Tuesday, June 28, 2022 Medway Planning and Economic Development Board Zoom Meeting

<u>PUBLIC HEARING CONTINUATION – 288 VILLAGE STREET MULTI-FAMILY HOUSE SPECIAL PERMIT, SITE PLAN, AND LAND DISTURBANCE PERMIT:</u>

Re: Multi-Family Development Major Site Plan Review 288 Village St. Medway, Massachusetts

Multi-Family Development 288 Village Street Major Site Plan Review June 13, 2022 Review Letter

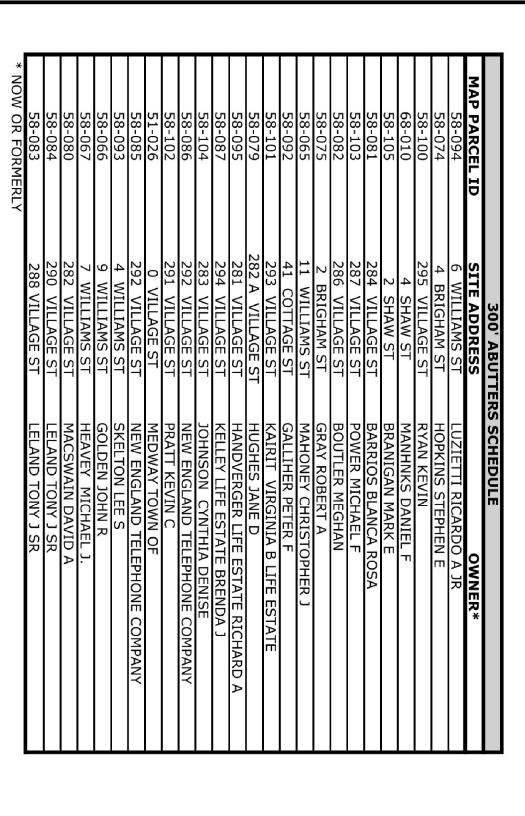
42. We recommend the Applicant protect the pop-up emitters with a stone or rip-rap collar to prevent them from being damaged during grass mowing and prevent erosion during discharge.

Rip-rap protection has been added to the plan

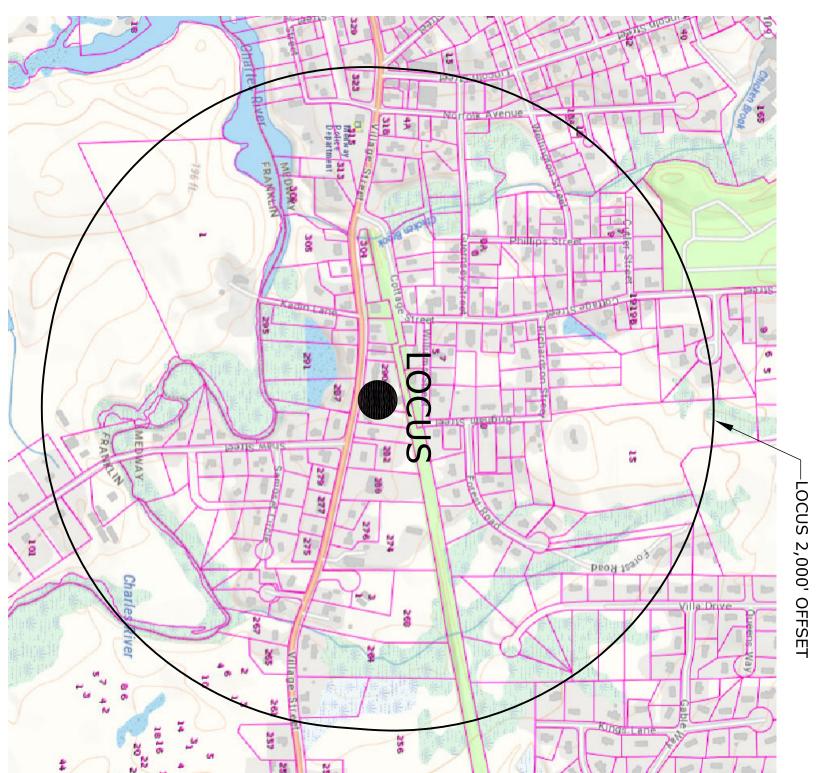
43. Please provide a detail of the pop-up emitters shown on the Plans.

A detail will be added to the plan and resubmitted.

Light Pole at Choate Park

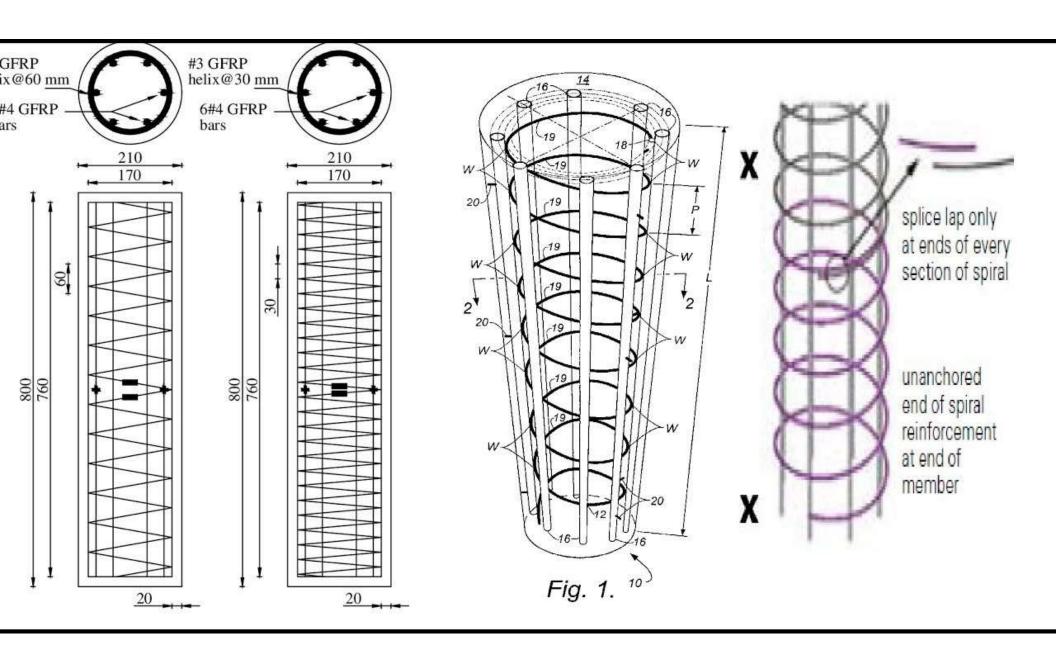
change is to change the footings on the light poles in the parking lot from 20" by 20" square to an 18" round cylinder. The round footing will include more rebar. A photo of this was shown. This is a more reinforced method.
